Access Compliance Report

Public Rights-of-Way

(Curb Ramps)

Intersection ID: N/A	Main Street: ARDREY_KELL_DR	Cross Street: PRINCETON_VILLAGE_DR	Location: SE
ADA ID: 4FA4B3A3CCD3	Ramp Type: BlendTrans2	Initial Pass/Fail: Pass	Overall Compliance: No
		Severity Score: 25

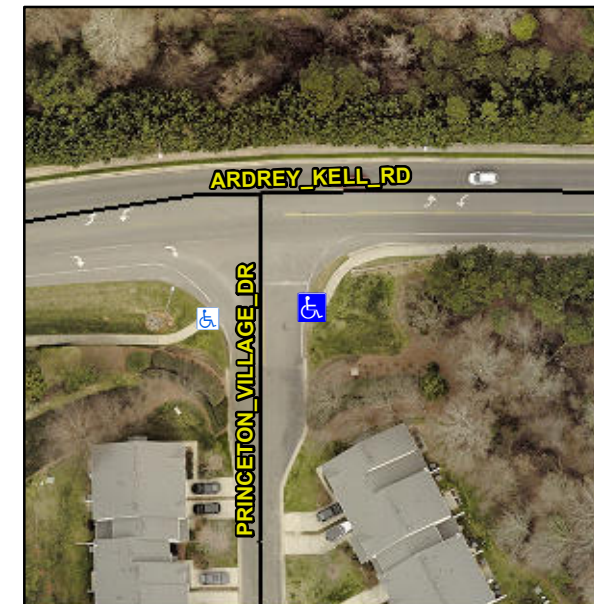
NO CURB

R305, R302.7.2

Compliance	Description	Data	Compliance	Description	Data
N/A	Ramp Length (in)	43.0	Yes	BlendTrans Slope (%)	0.9
Yes	Ramp Width (in)	60.0	Yes	BlendTrans XSlope (%)	1.2
N/A	Flare Type LT	None	N/A	Flare Type RT	None
N/A	Flare Slope LT (%)	N/A	N/A	Flare Slope RT (%)	N/A
N/A	Flare Traversable LT?	N/A	N/A	Flare Traversable RT?	N/A
N/A	Landing Length (in)	N/A	No	DWS Provided?	No
N/A	Landing Width (in)	N/A	N/A	DWS Contrast?	No
N/A	Landing Slope (%)	N/A	N/A	DWS Length (in)	N/A
N/A	Landing X Slope (%)	N/A	N/A	DWS Full Width?	No
N/A	Landing Curb? (Y/N)	No	N/A	DWS Offset (in)	N/A
N/A	Shared Landing?	No			
Yes	Gutter Ponding?	No	Yes	Gutter Slope (%)	5.0
No	Gutter Lip Ht (in)	1.0	Yes	Gutter X Slope (%)	1.1
N/A	Painted X Walk1?	No	N/A	Painted X Walk2?	N/A
	X Walk 1 Direction	To W		X Walk 2 Direction	N/A
	X Walk 1 Width (in)	N/A		X Walk 2 Width (in)	N/A
	X Walk 1 Slope (%)	4.2		X Walk 2 Slope (%)	N/A
	X Walk 1 X Slope (%)	1.8		X Walk 2 X Slope (%)	N/A

N/A	Ramp inside XWalk1?	N/A	N/A	Ramp inside XWalk2?	N/A
	Road Slope (%)	1.8		Clear Space?	Yes
	Road X Slope (%)	4.2	N/A	Clear Space to XWalk (in)	N/A
Yes	Any Obstructions?	No	Yes	Storm Grate/Utility Hazard?	No
	Obstruction Type			Storm Grate/Utility Type	
		N/A			N/A
			Yes	Surface Condition? (G/P)	Good
			N/A	Curb Slope (%)	N/A

**Install Detectable Warning System.
Grind Gutter Lip.**
